EXPLANATION OF SIGNIFICANT DIFFERENCES

Outboard Marine Corporation Superfund Site
Outboard Marine Corporation Plant 2 (Operable Unit 4)
Waukegan, IL

July 2012

U.S. Environmental Protection Agency
Region 5

FIGURE 4
DUNE SOIL REMEDIATION AREA

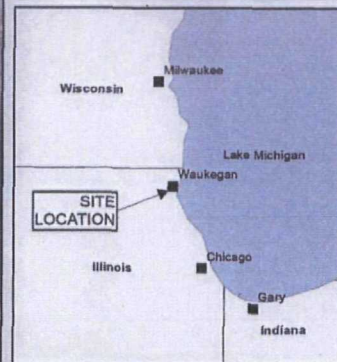
The Dunes Area, which encompasses Area 5, is an area where excavation was completed but PCB contamination has since been discovered at the margins of the excavation and to the north and east of Area 5 (see Figure 4). The main area of concern is the area directly east of the East Containment Cell. This area contained two samples having PCB concentrations of 140 ppm and 190 ppm respectively, both exceeding TSCA criteria (50 ppm PCB). Since this contamination cannot be excavated without endangering the integrity of the East Containment Cell slurry wall, the area must be capped and restored. Figure 5 depicts the extension of the existing East Containment Cell cap. The remaining positive samples in the Dunes Area to the east of Area 5 ranged from less than one ppm to 19 ppm. These areas will be addressed by excavation to achieve 1 ppm PCB and backfilling with clean fill.

Remediation activities were completed within the Dunes Area, which is inclusive of Area 5, to the extent prescribed by the 2008-2009 RD documents. Subsequently, contamination exceeding the cleanup levels was identified on the northern and western margins of the excavation, including contamination near the East Containment Cell and the Dunes Area on the east. A supplemental investigation also identified contamination to the north and east of Area 5. This ESD addresses the contaminated areas by removing soil where possible. A cap is being installed within the area adjacent to Area 5, along the eastern boundary of the East Containment Cell. This cap covers soil that cannot be removed without jeopardizing the integrity of the East Containment Cell and drainage system. The multi-layered cap is constructed according to the criteria provided in U.S. EPA's TSCA Landfill Inspection Guidance Manual (U.S. EPA 1990). The location of the cap area and a conceptual cross section are shown on Figure 5. As previously mentioned, other unanticipated post-excavation areas exhibiting residual contamination above cleanup levels may also be capped if sufficient excavation and backfilling are not possible.

FIGURE 5
 TSCA CAP EXTENSION

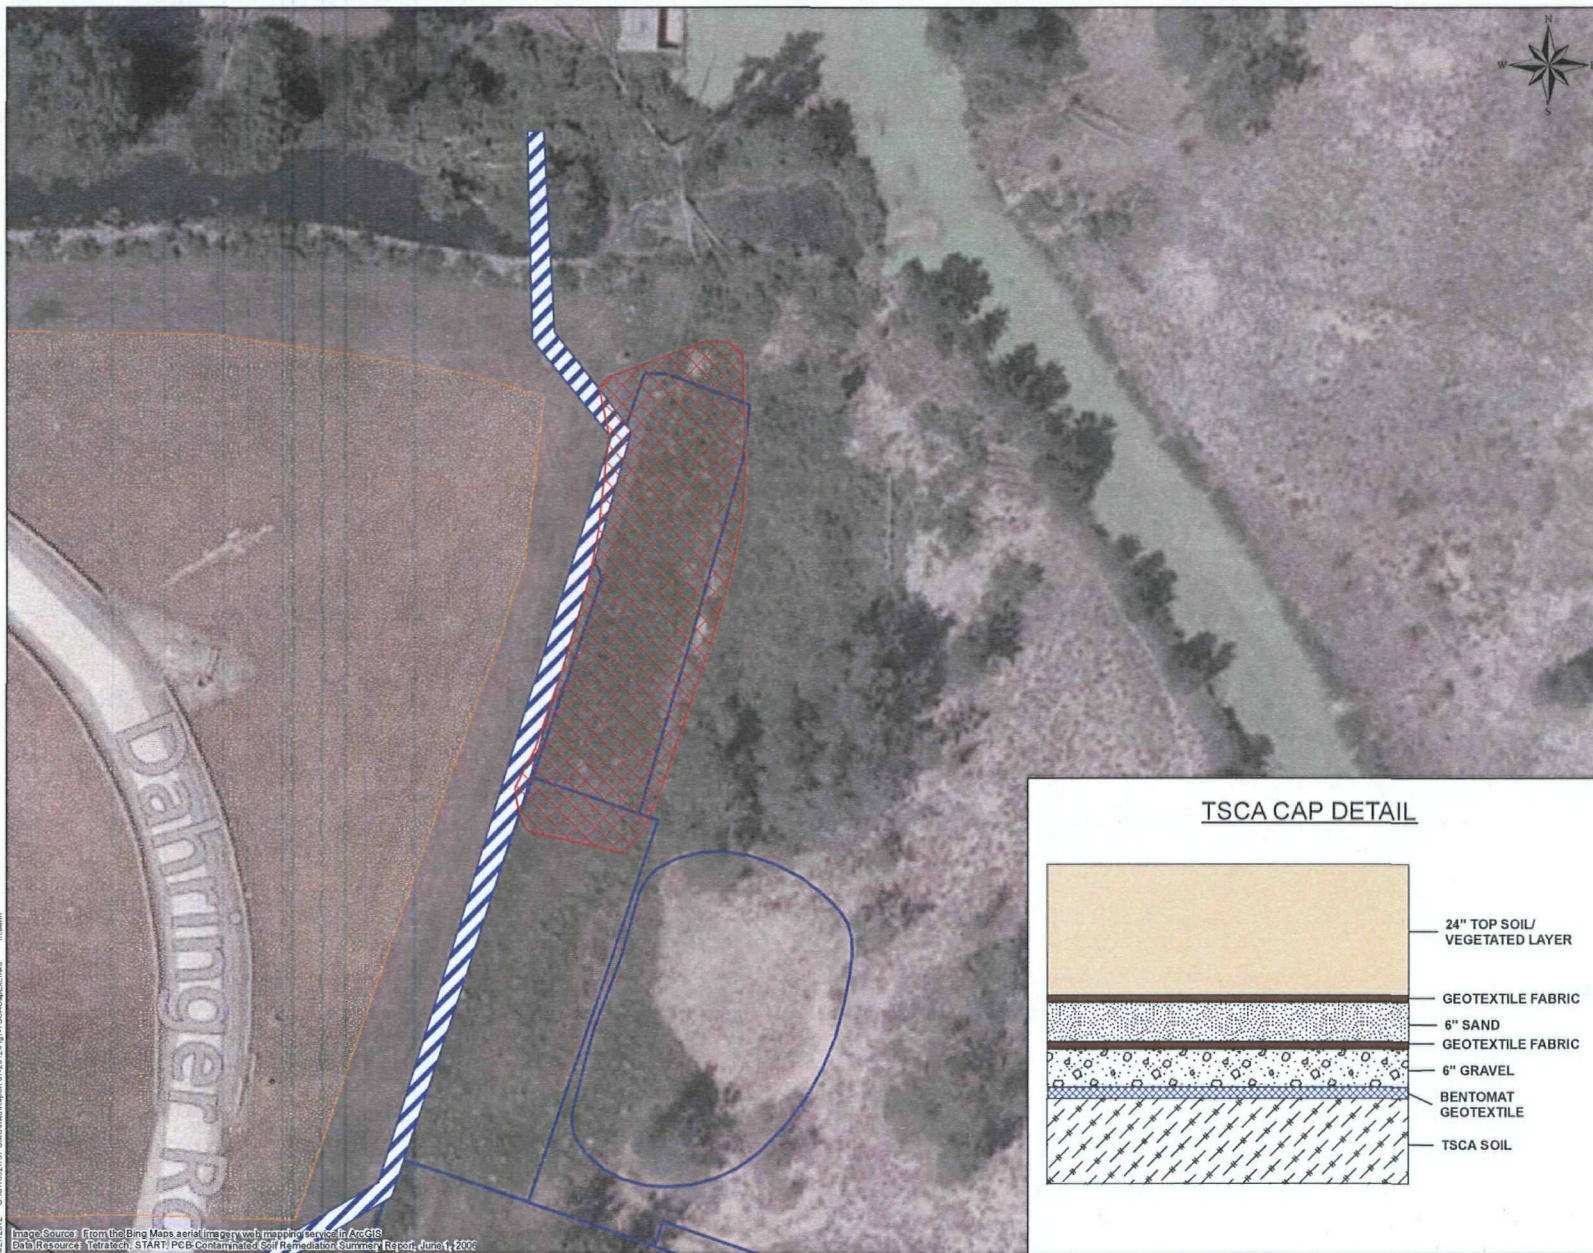
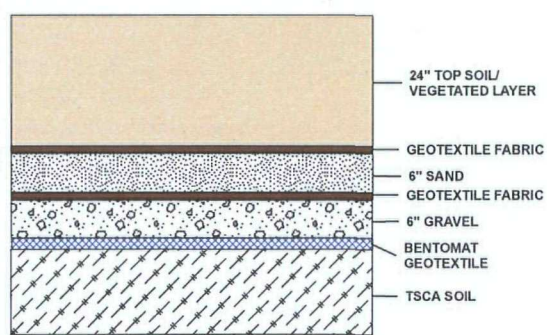
The major additions include constructing a multi-layer cap within the Dunes Area that will extend eastward from the East Containment Cell. In addition, portions of the North Ditch and other areas on the eastern part of the Site, which contain contaminated soil and sediment above one part-per-million of polychlorinated biphenyls and/or two ppm of polycyclic aromatic hydrocarbons, must also be excavated and either capped or backfilled with clean fill and capped. Certain areas of the Plant 2 building slab require additional excavation where possible, and backfilling with clean fill. This ESD documents these remedy changes, as the 2007 ROD remedial action objectives cannot be fully achieved under the ROD as presently written.

<ul style="list-style-type: none"> • Backfill excavated areas with clean fill to grade. 	<ul style="list-style-type: none"> • No functional change, however more excavated areas will need to be graded, filled with clean soil, and revegetated.
<ul style="list-style-type: none"> • Demolish PCB-impacted OMC Plant 2 building and disposal of demolition materials in appropriate facility. 	<ul style="list-style-type: none"> • Not addressed through this ESD.
<ul style="list-style-type: none"> • Excavate contaminated soil containing greater than 1 ppm PCBs and/or 2 ppm cPAHs from the Dune Area • Dispose of excavated soil in appropriate off-site facility (TSCA-compliant landfill or municipal landfill); backfill to grade with clean soil; and, revegetate. 	<ul style="list-style-type: none"> • No functional change concerning contaminated soil excavation, except that no further excavation will occur in certain locations where the integrity of the East Containment Cell could be jeopardized. In these areas, a TSCA-compliant cap will be installed and extended eastward from the existing containment cell cap. • No functional change

FIGURE 7
OFF-SITE WATERWAY SEDIMENT
REMOVAL AREAS AND CONFIRMATION
SAMPLING RESULTS

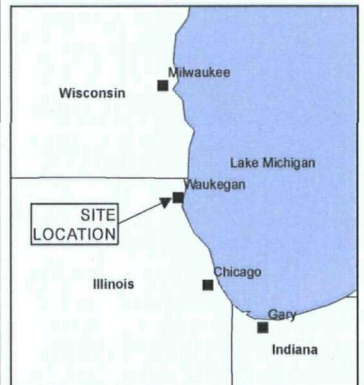
On-site portions of the North Ditch (Area 3) that remain contaminated with PCBs after being excavated to the prescribed depth will be capped with a geotextile fabric, followed by a sand layer, and rock armor surface. The on-site areas of the North Ditch showed PCB contamination ranging from nondetect to 700 ppm, with the next highest level at 290 ppm. Figure 6 depicts the North Ditch sediment cap. Sediment contamination in the off-site portions of the North Ditch largely showed PCB levels above the cleanup level of 1 ppm but below 50 ppm. These off-site portions have since been excavated to meet the cleanup level (see Figure 7).

On-site and off-site portions of the North Ditch will be addressed under this ESD. The northern and western utility corridors will be handled separately under the upcoming ROD Amendment. The RAOs established in the RD documents were based on recreational use and sediment erosion. The off-site North Ditch sediment will be addressed by excavating contaminated sediment and disposing of the material in an off-site applicable facility. Temporary coffer dams are used to isolate sections of the ditch in order to mechanically excavate the sediment (see Figure 7). The on-site portions of the North Ditch are being addressed by excavating contaminated sediment also. Contaminated sediment below the remedial design depth of 577 ft. MSL is being capped to contain contaminated sediment and prevent the erosion of contaminants to the downstream ditch. The capping involves anchoring a geotextile fabric at the sides of the ditch to cover the excavation. Six inches of sand will be placed over the fabric, followed by a six-inch rock-armor surface layer for protection, as described in the Supplemental Design Report of September 2011⁹. (See Figure 6).

FIGURE 4
PCB RESULTS - SUB SLAB SOIL

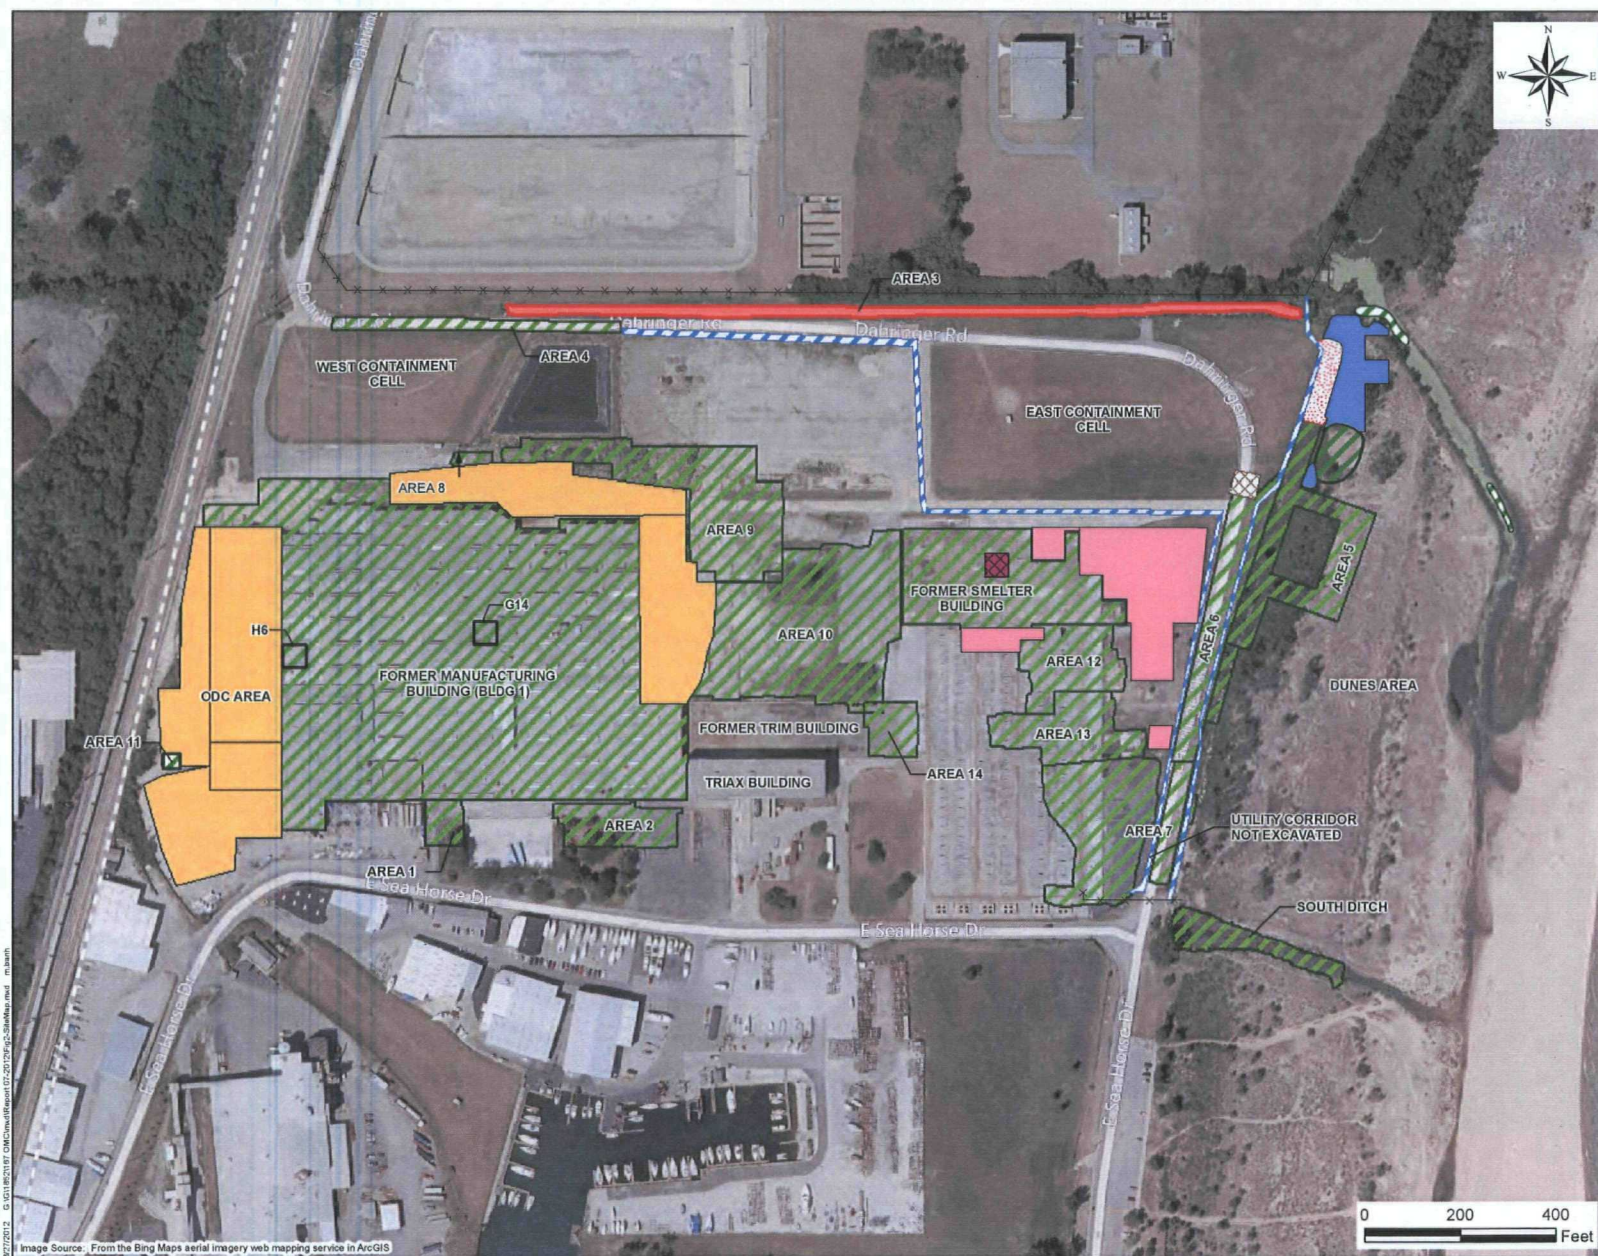
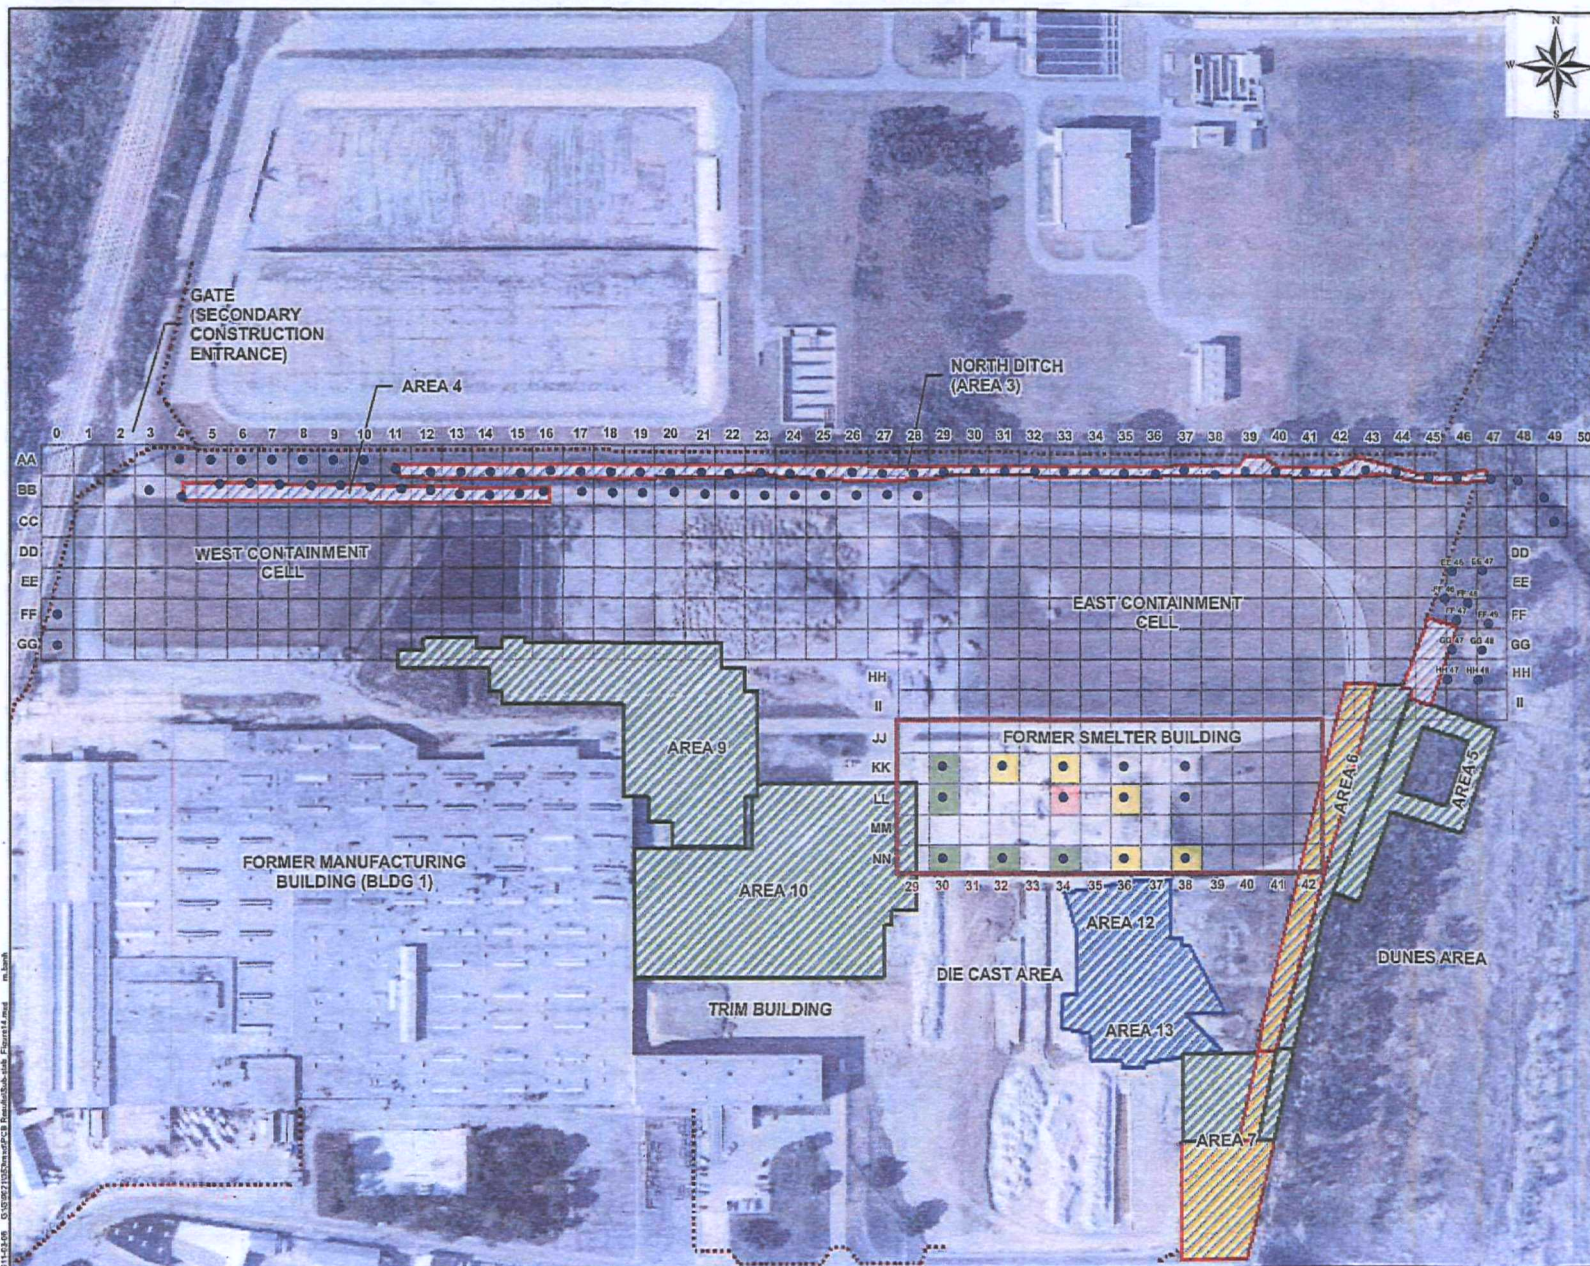
Remediation of the Plant 2 Building slab and sub-slab soil was completed in July 2011. The RAOs were met in soil above the groundwater table. After discovering contamination in the Smelter Slab Area during remediation of the adjacent soil areas (Areas 10, 12 and 13), the slab and sub-slab soils were removed and the soil was remediated to meet RAOs. Residual soil contamination exceeding TSCA criteria of 50 ppm PCB is still present below the groundwater table at some areas beneath the Plant 2 building smelter slab on the eastern side of the Site. More recently, a residual PCB concentration of 880 ppm was found in one sub slab soil grid area. The highest PCB level at the margins of the soil remediation area was 40 ppm. These areas will be further excavated to meet the cleanup levels, except in the case where the water table is encountered. The excavations will be backfilled with clean material, graded and vegetated for stability.

Elsewhere throughout the building slab, soils were remediated to meet cleanup levels or were excavated below the water table. The Trim Building Slab located immediately north of the Triax Building was left in place for use as a concrete pad to support water treatment equipment to be used for the OU 1 Waukegan Harbor sediment remediation project. The Triax Building itself will be used to house portions of the treatment operation. When OU 1 remediation is complete, the city of Waukegan is responsible for the disposition of the former Trim Building and slab (see Figure 9).
